Addendum

Global technical regulation No. 6

SAFETY GLAZING MATERIALS FOR MOTOR VEHICLES
AND MOTOR VEHICLE EQUIPEMENT

(Established in the Global Registry on 12 March 2008)

Figure 2: Prescribed points of impact for uniformly toughened glass panes

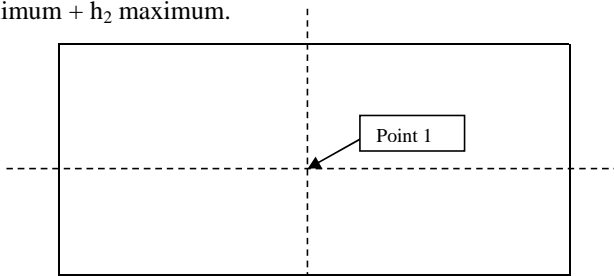
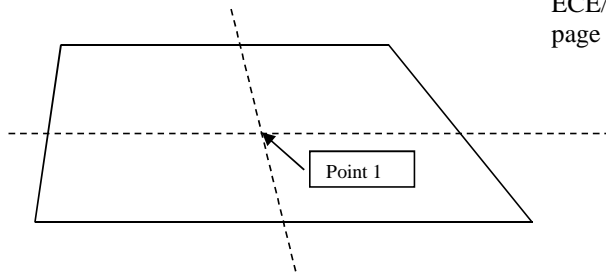
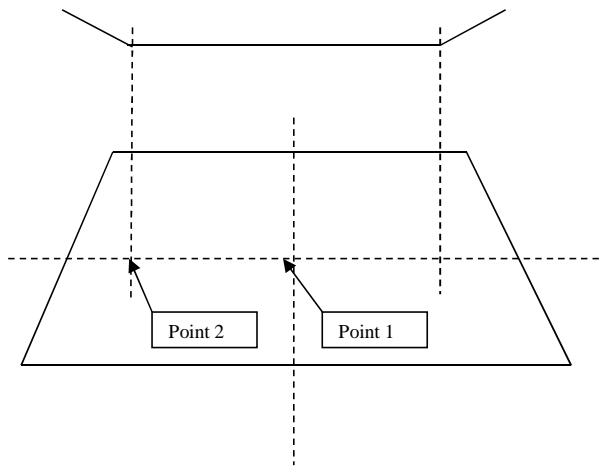
Kommentar [m15]: New Section 7.2: Change Proposal by Industry (OICA/ JAMA / ALLIANCE) presented in 4th meeting IWG PSG to split test specification in case of overhead glazing

Kommentar [m16]: New Section 7.2: Change Proposal by KOREA presented in 4th meeting IWG PSG to split test specification in case of overhead glazing
